RHODE ISLAND ATOMIC ENERGY COMMISSION
RESEARCH REACTOR
LICENSE NO. R-95
DOCKET NO. 50-193

RESPONSES TO NRC STAFF REQUEST FOR
ADDITIONAL INFORMATION
FOR LICENSE RENEWAL REVIEW

Fourth Response to Request for Additional Information Letter Dated April 13, 2010

**Equilibrium Fission Products
Change Fuel Temperature
Only**

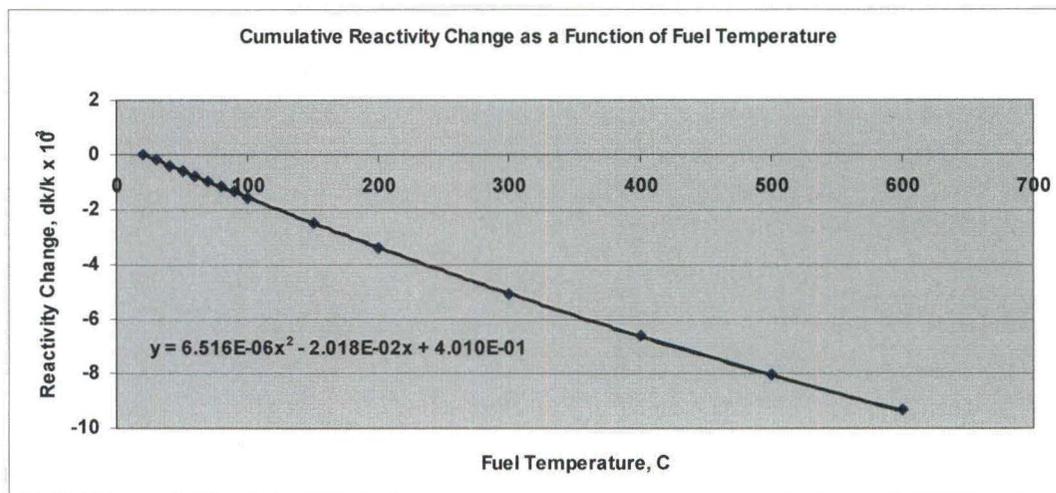
4.13 Table 4-3 includes the Doppler coefficient of reactivity over the temperature range of 20-40 degrees Celsius. This temperature range appears to apply to the coolant temperature and not the fuel temperature. Provide the Doppler coefficient of reactivity over the range of fuel temperatures anticipated during all allowed modes of reactor operation and reactor transients.

Reactivity coefficients were recalculated for this RAI for increasing the fuel temperature only using the methods described in RAI 4.11. The reactivity coefficients are shown below for a fuel temperature range between 20 °C and 600 °C.

Measured Pump Coastdown Curve

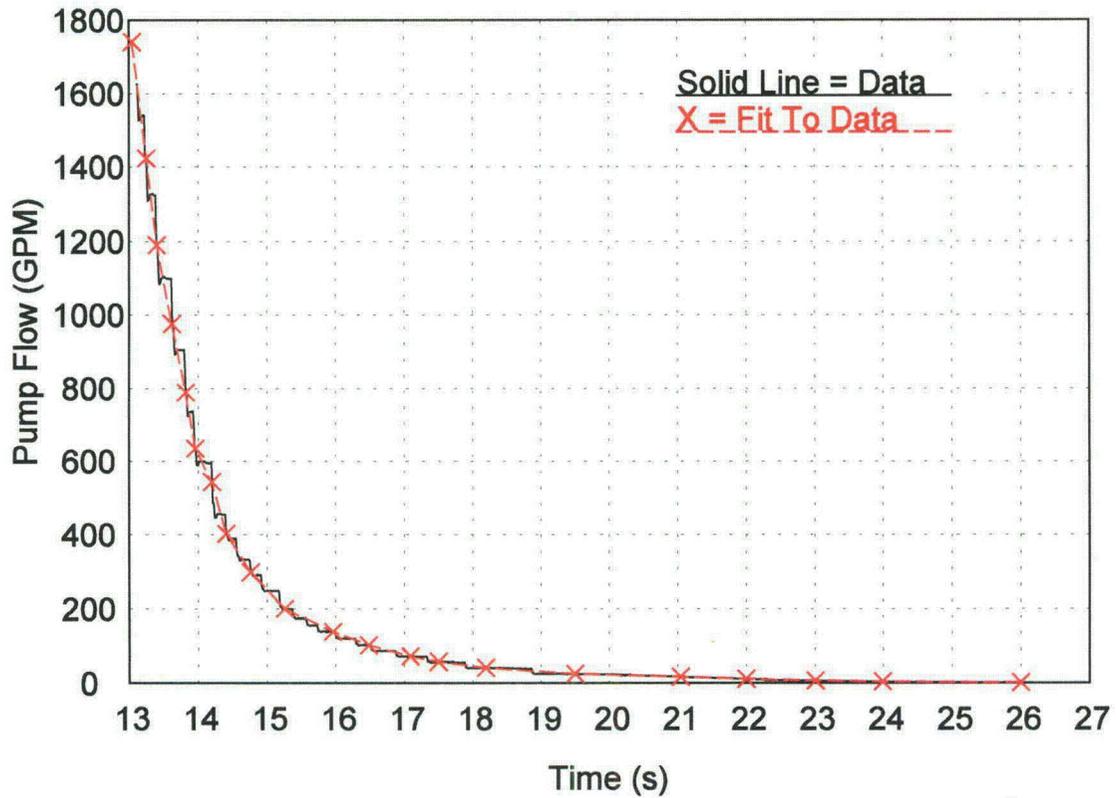
Provide an analysis that supports this statement. Justify all assumptions made in the analysis.

The transient was initiated by a loss of power to the pump. RINSC personnel have measured the pump flow after a pump trip. The measured results are shown in the figure below. Also shown is a smoothed fit to the data. The smoothed fit was used to specify the pump flow in the RELAP5 calculations.

Figure 7.2 Reactor period as a function of positive and negative reactivity for a ²³⁵U-fueled reactor.

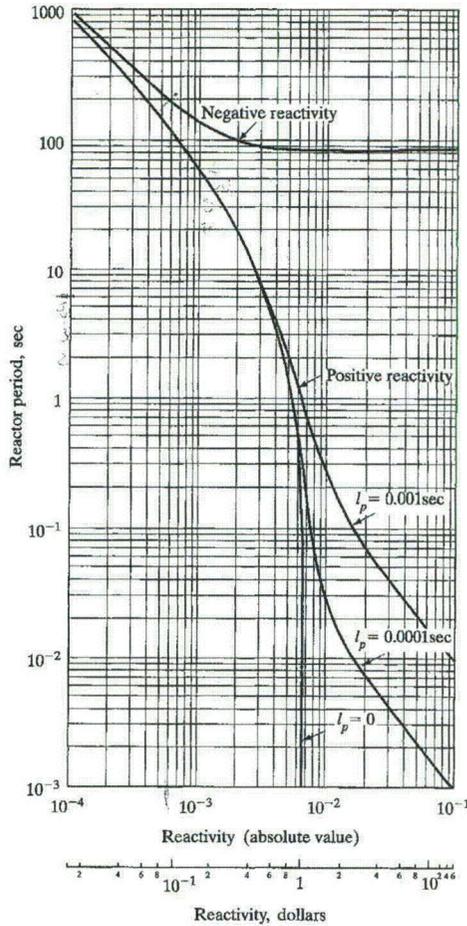
- 14.61 The bases for TS 3.1.4 state that the individual reactivity worth of an experiment is limited to a value that will not produce a stable reactor period of less than 30 seconds. Explain whether this statement applies to all types of experiments. Provide an analysis that supports this statement, and revise the proposed TS as appropriate.

The reactivity of moveable experiments is limited to 0.08 %dK/K in order to assure that they will not produce a stable period less than 30 seconds, and to assure that the reactivity can be compensated for by the action of the control and safety systems without exceeding any safety limits. The following diagram from Lamarsh; John R., Baratta, Anthony J., (2001), *Introduction to Nuclear Reactor Engineering* (3rd ed.), Prentice Hall, shows that for a U-235 fueled core, with a positive reactivity insertion of $0.08\% \text{ dK/K} = 0.0008 = 8 \text{ E } 10^{-4}$, the period would be approximately 80 seconds, which is easily compensated for by the action of the control and safety systems.

This was confirmed by an analysis performed by Argonne National Laboratory. In that analysis, the initial assumptions were that:
